## Product Change Notification (PCN)

Affected Part Number(s)	PCN No.
LZP-L0MD00 LZP-L4MD00 LZP-L0H100 LQP-Lxxxxx-0xxx	61

Part Description	Date
LZP RGBW Dome Lens on Star MCPCB LZP RGBW Flat Lens on Star MCPCB LZP Horti on Star MCPCB Custom LZP Emitter on "L" Star MCPCB	2/13/2020

### Mechanical Dimension

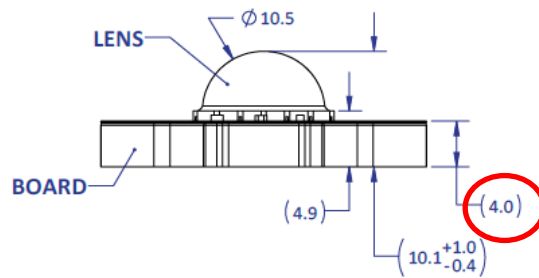
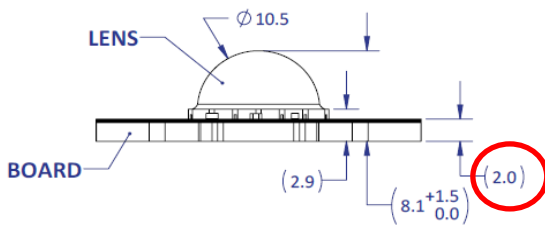
Description & Reason of Change
MCPCB thickness increased from 2.0mm to 4.0mm to increase product mechanical strength

2.0mm thick MCPCB (Old)

4.0mm thick MCPCB (New)
